Appl. No. 10/709,682
Amdt. dated May 25, 2006
Reply to Office action of Feb. 28, 2006

Amendments to the Drawings:

ARM SUPPORT WITH HOUSE PAD
ANDREA BOMBELLI

Fig. 2

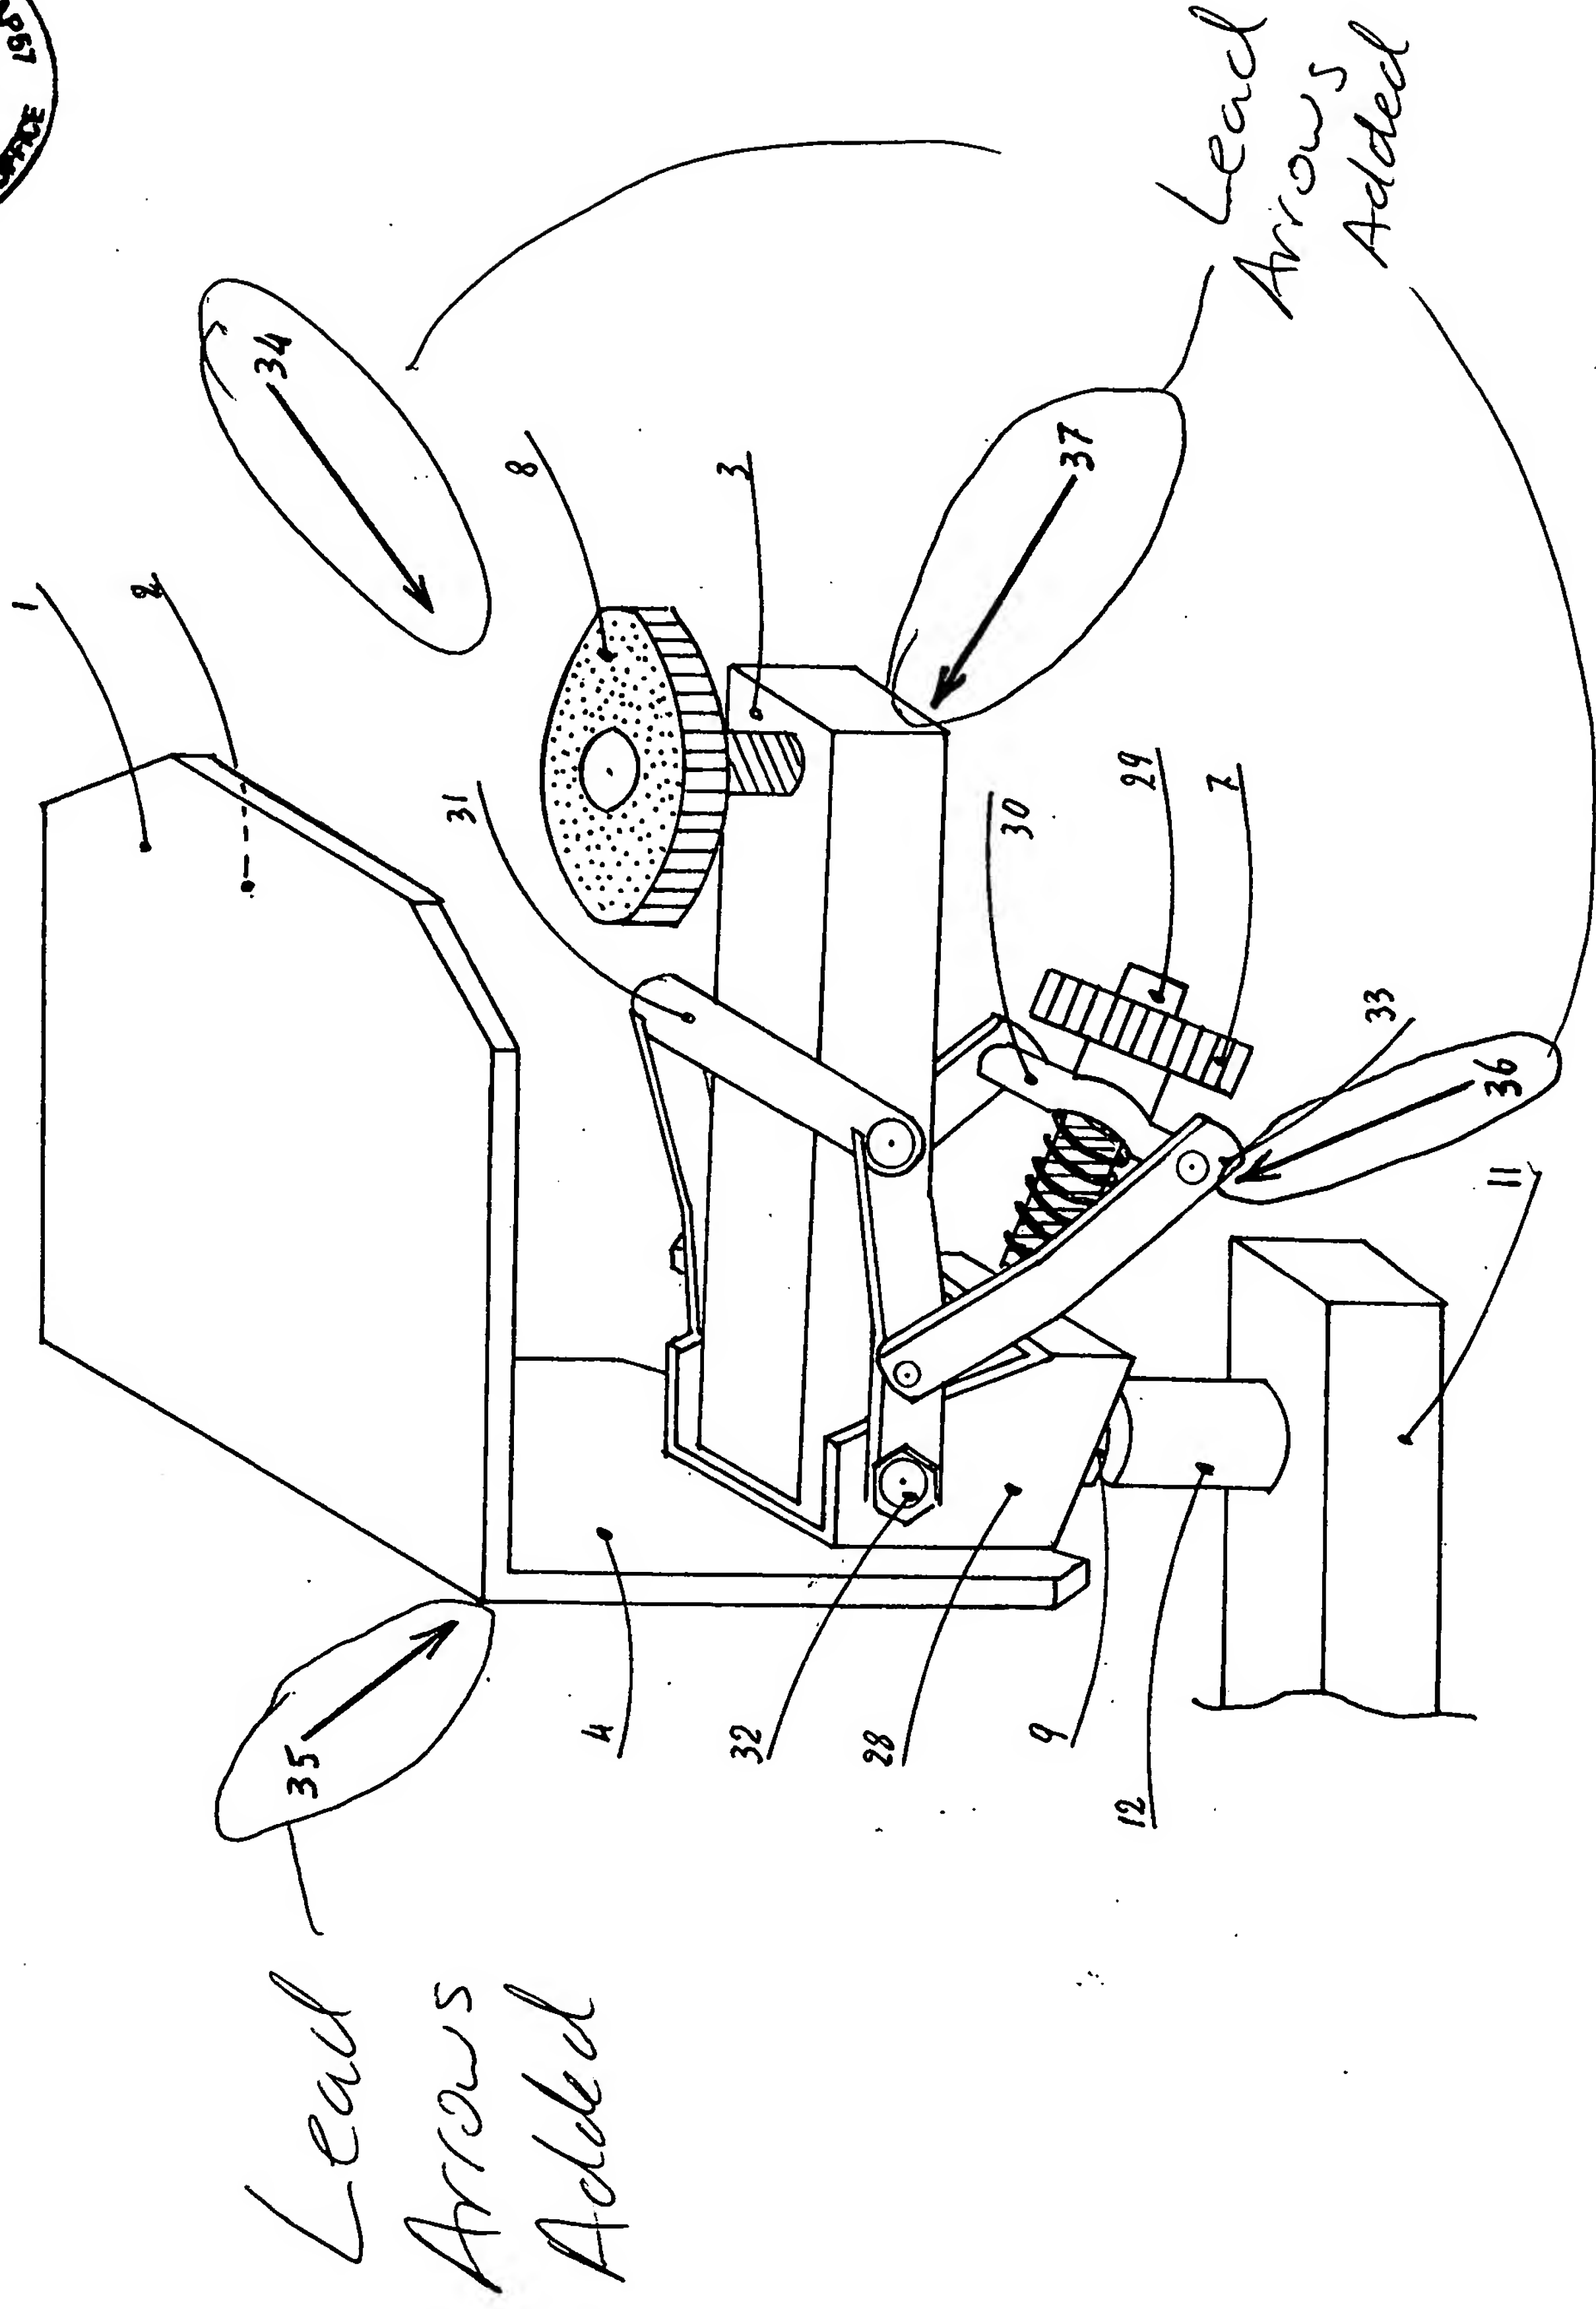
The attached sheets of drawings include changes to Figure 2, Figures 3(a) and 3(b), Figure 4(a), and Figures 5(a) and 5(b).

Lead arrows have been added to all above figures in support of amendments to specification. These amendments to specification reflect Examiner's request to reduce "the use of multiple reference numerals to identify a single element".

Figures 2, 3(a) and 3(b), 4(a), and 5(a) were modified to reflect changes in the specification. Figure 5(b) was modified to add the bracket as required in an exploded view.

Fig. 3 (b)

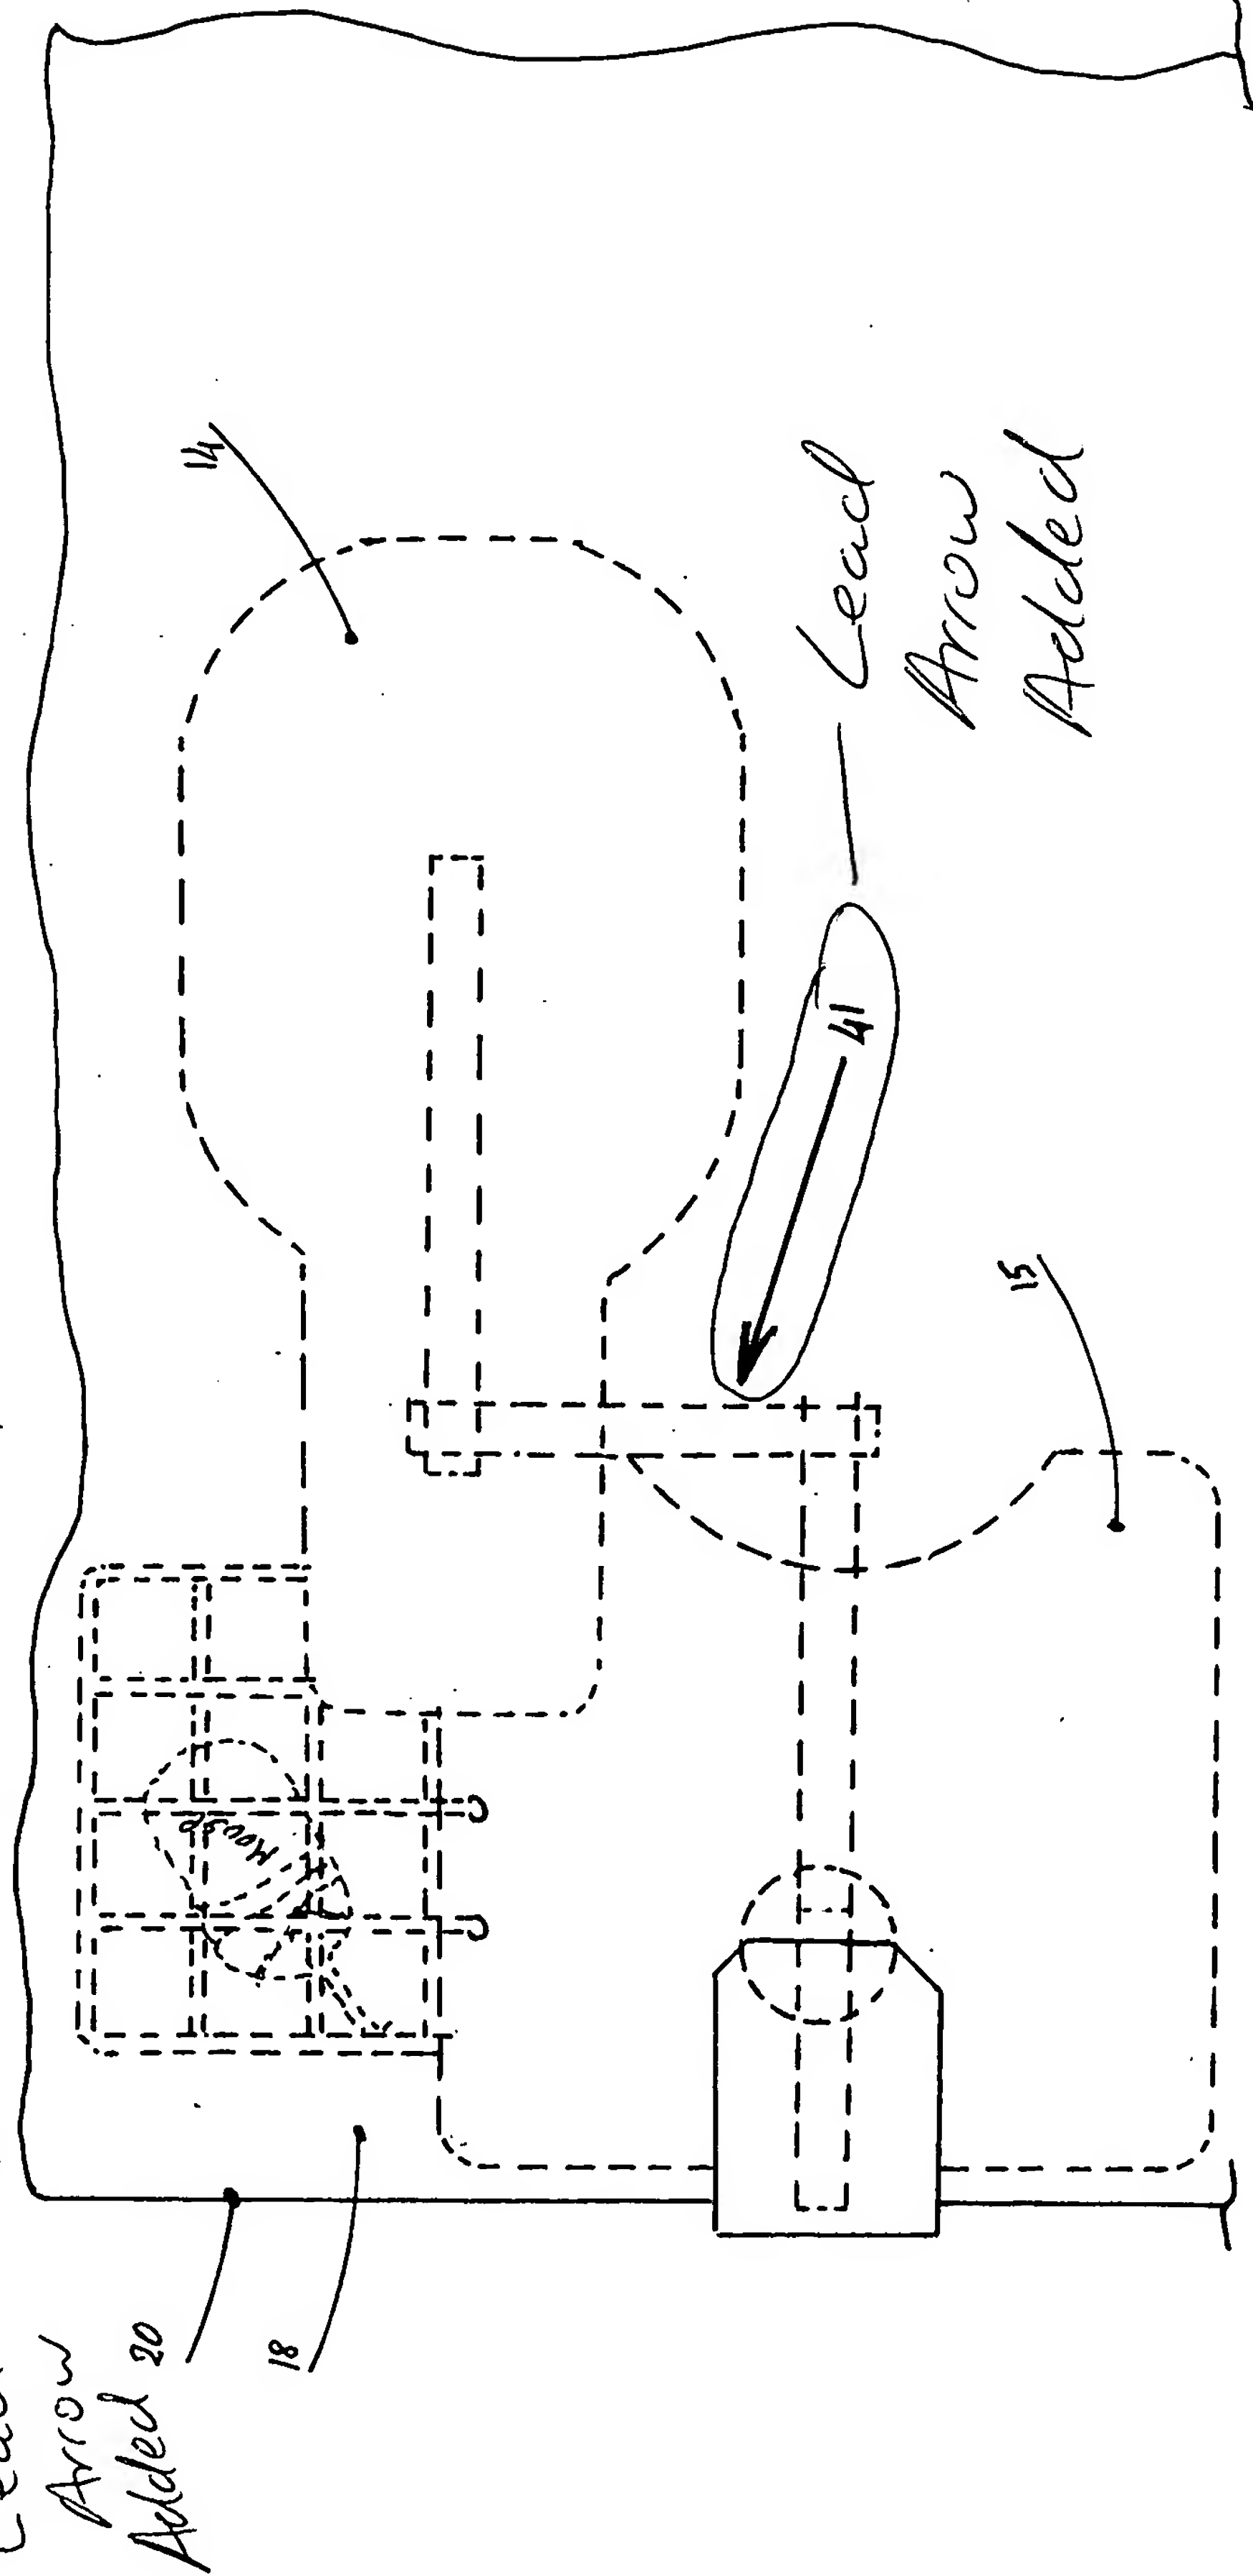
ARM SUPPORT WITH MOUSE PAD
ANDREA BONIBELLI
— Lead Arrow Added

Fig. 5 (a)

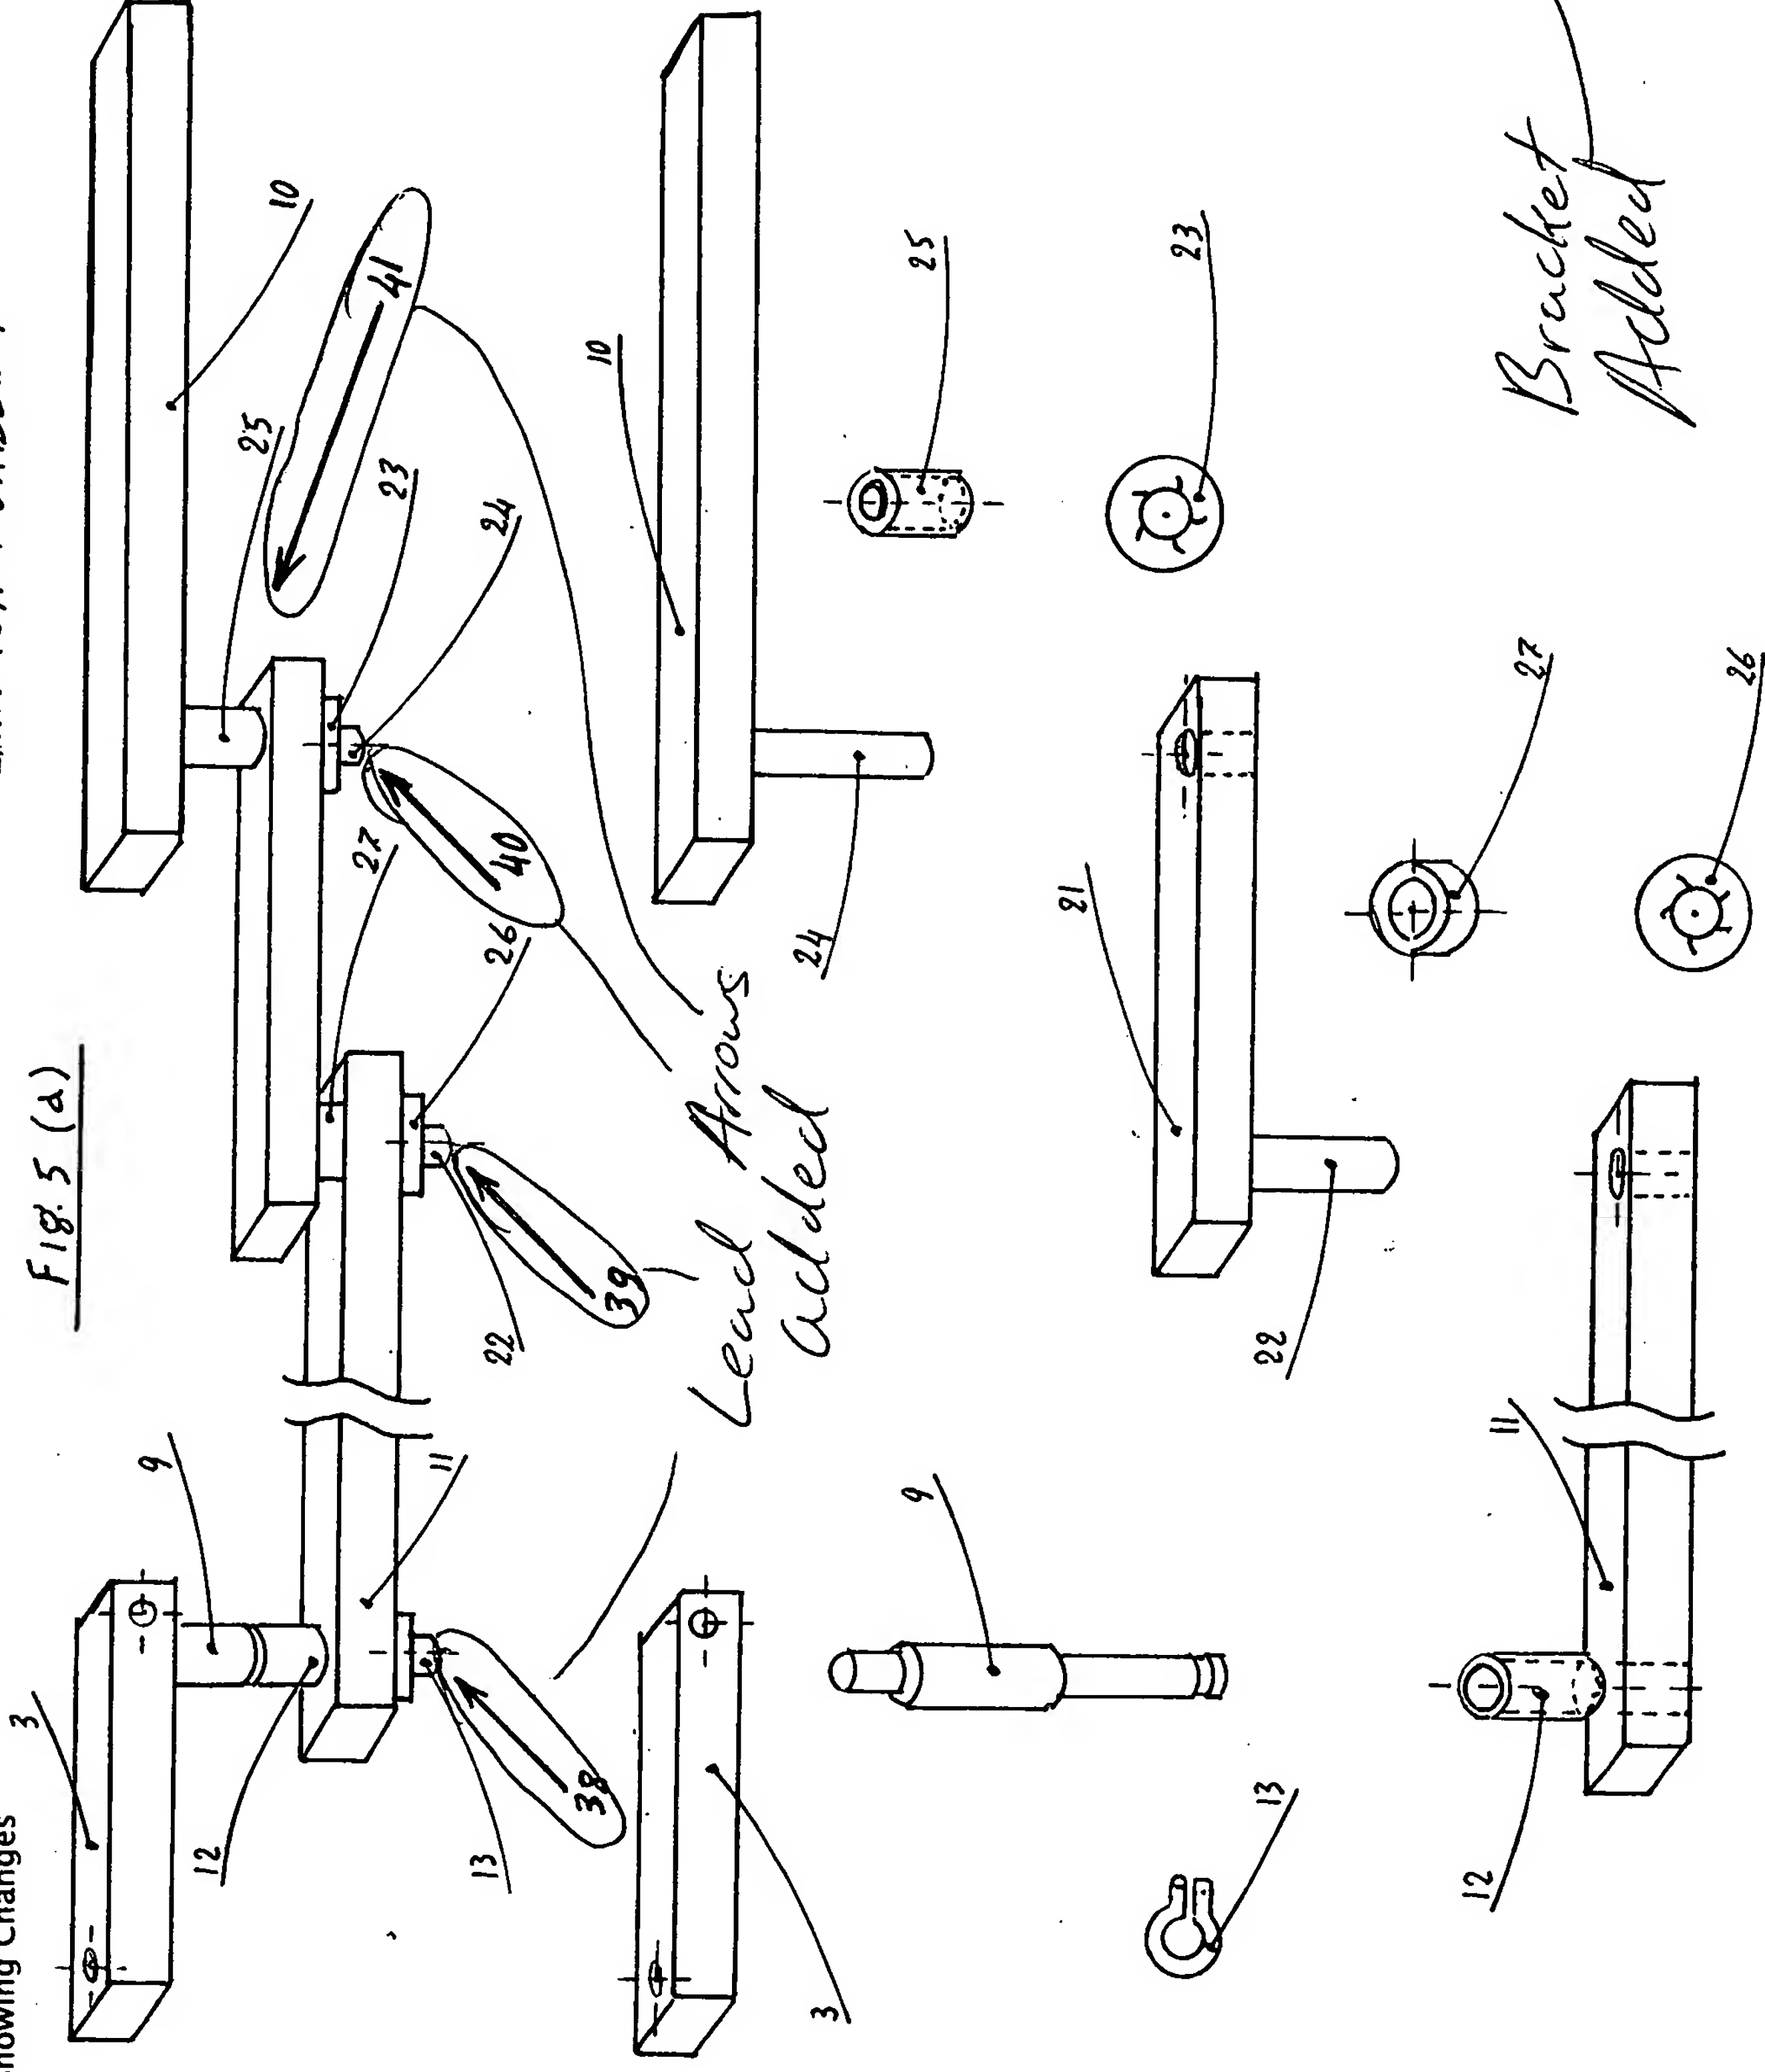
In Figure 5(b), a bracket has been added as requested by Examiner to comply with rule 184(h)(1).
